MEMORANDUM

TO: Village President and Village Board  
FROM: James M. Hogue, Village Planner  
DATE: November 27, 2012  
RE: Board & Commissions Report for 11/27/12

**AC; 11.26.12 Re-scheduled Regular Meeting – 3 action items**

# QB1B

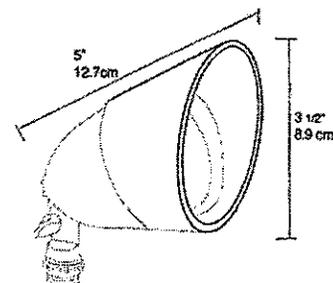
Planner Hogue explained the request noting that A “Quartz Bullet” floodlight fixture is proposed using a quartz halogen light source. This fixture is located near the drive into Mill Ponds and is approximately 18” from grade. This fixture is black in color and is equipped with a “integra-hood glare shield” designed to minimize glare and direct the light to a specific target. The lighting system is 120 volt system utilizing a 75 watt light bulb.

As the petitioner was not present representatives of the LGBCP indicated the fixture as identified by Planner Hogue was actually part of the illumination of the wind sculptures (reviewed in item 2) and the identical fixtures were proposed to be ground mounted on either side of the newly installed “Long Grove Café Sign” and pointing up to illuminate both sides of the sign face.

- A maximum of two (2) “Quartz Bullet” floodlight fixtures (RAB Lighting QB1B) be ground mounted on either side of the Long Grove Café Sign;
- Lighting is to be directed to illuminate the face of signage only; and
- Any “power boxes” upon which the fixtures are mounted be painted to match the color of the fixtures.
